Amendments to the Drawings:

REMARKS

F I G . 1

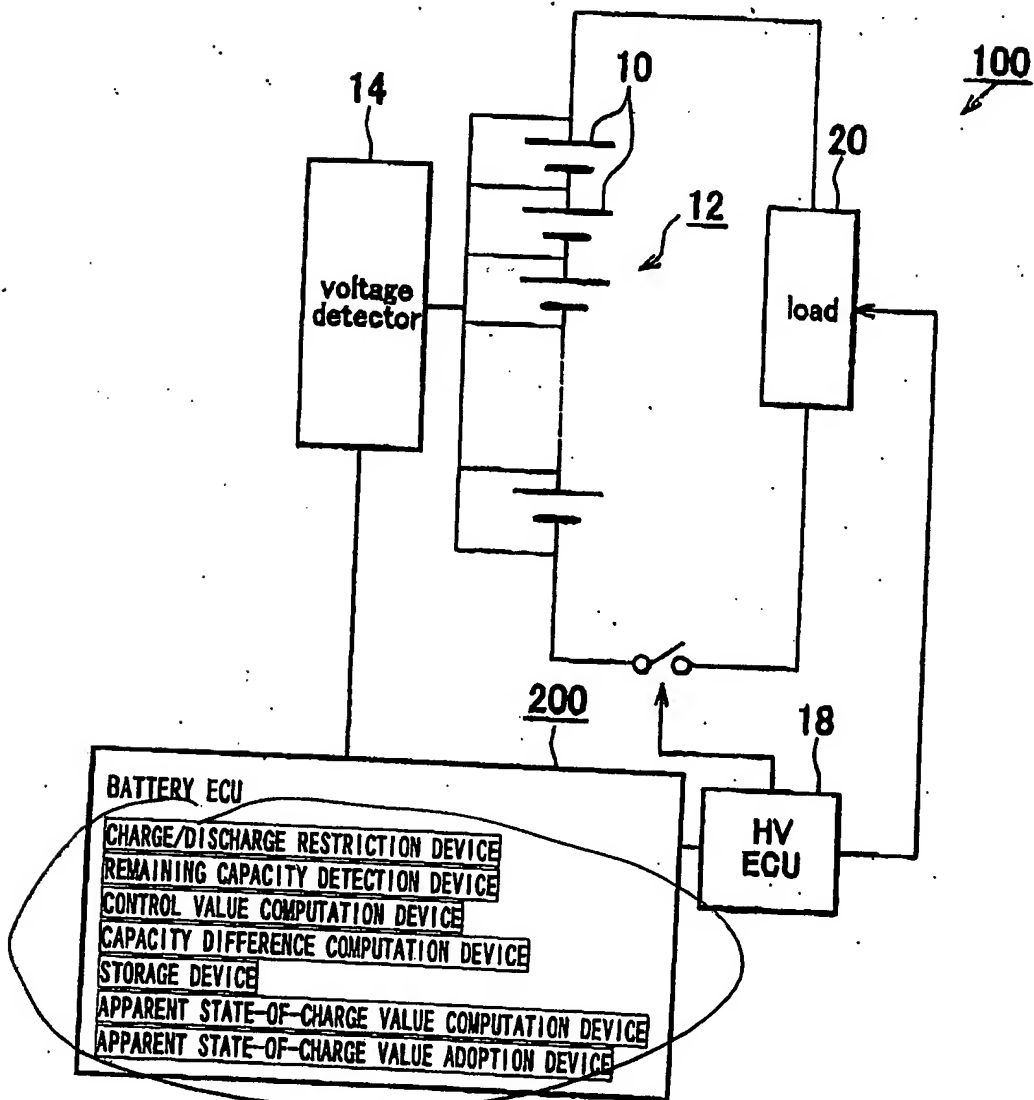
The attached sheets of drawings include changes to FIG. 1. These sheets, which include FIG. 1, replace the original sheet including FIG. 1. In FIG. 1, text has been added to clarify that reference numeral 200 represents a charge/discharge restriction device, a remaining capacity detection device, a control value computation device, a capacity difference computation device, a storage device, an apparent state of charge value computation device, an apparent state of charge value adoption device.

The drawings are objected to under 37 CFR 1.83(a) because they must show every feature of the invention specified in the claims. The Applicant respectfully submits that, in amended FIG. 1, the previously omitted elements have been added.

✳ Elements Added ✳
